Amendments to the Drawing

Remarks

ser. 10/613, 019
mark-up sheet

Fig. 33(d)

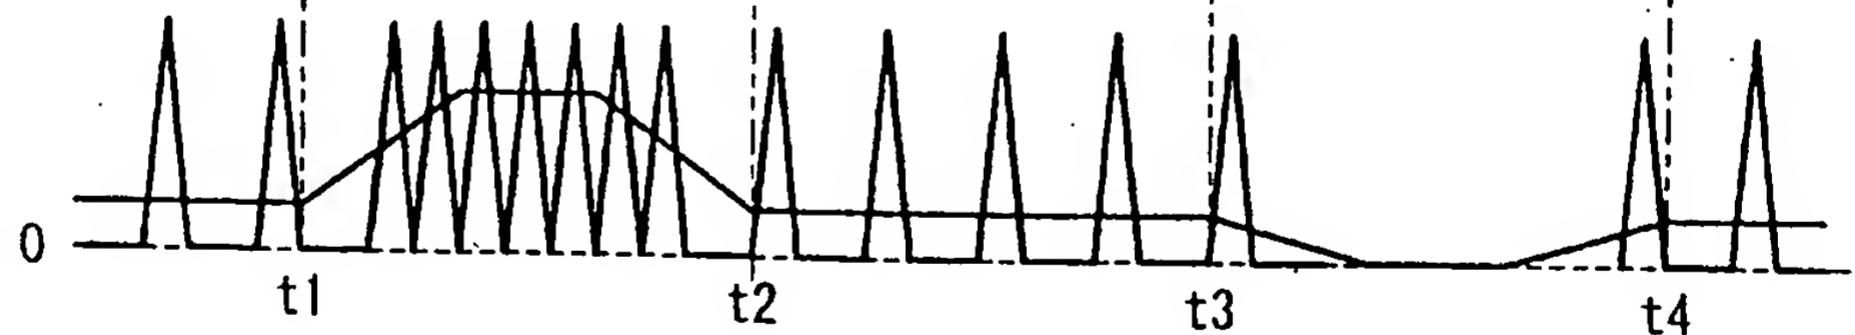
In Figs. 33(a) to 33(d), one of the drawings originally shown was not labeled, and the locations of Figs. 33(b) to 33(d) were incorrect. Therefore, the locations of Figs. 33(b) to 33(d) have been corrected, and label of Fig. 33(e) has been added.

In regard to Figs. 33(a) to 33(d), although five drawings are shown in one sheet, labels of Figs. 33(a) to 33(d) were indicated. Figs. 33(a) to 33(e) should be labeled.

The marked up drawings (Fig. 6 and Figs. 33(b) to 33(d)) and replacement sheets thereof are attached herewith.

In accordance with 37 CFR § 1.121, replacement drawing sheets for Figs. 6 and 33(a)-33(e) are attached hereto.
